33521B-02

# Modification Recommended Service Note

## 33521B Function Generator

Serial Numbers: MY000000000 to MY57700600 and SG000000000 to SG57700600

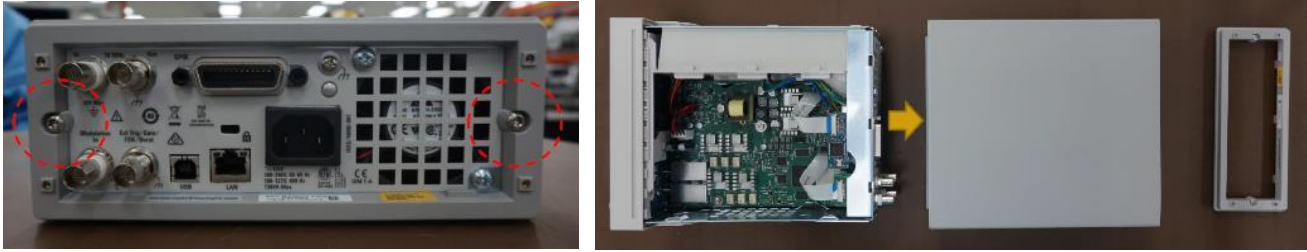
**The Problem** – Some customers have reported that, when line power is applied to the instrument but the instrument is NOT turned on (“Standby Mode”), some instruments will emit an audible high-pitched whistle or whine. To fix this, the existing power supply must be replaced with a newly designed power supply, as detailed in the solution below.

**Old Noisy XP Power Supply (PN xxxx-xxxx)**

**New MeanWell Power Supply (PN 0950-6082)**

The solution is to replace the old power supply with a new one. The old power supply was manufactured by XP Power. The new power supply is manufactured by MeanWell, and has Part Number 0950-6082.
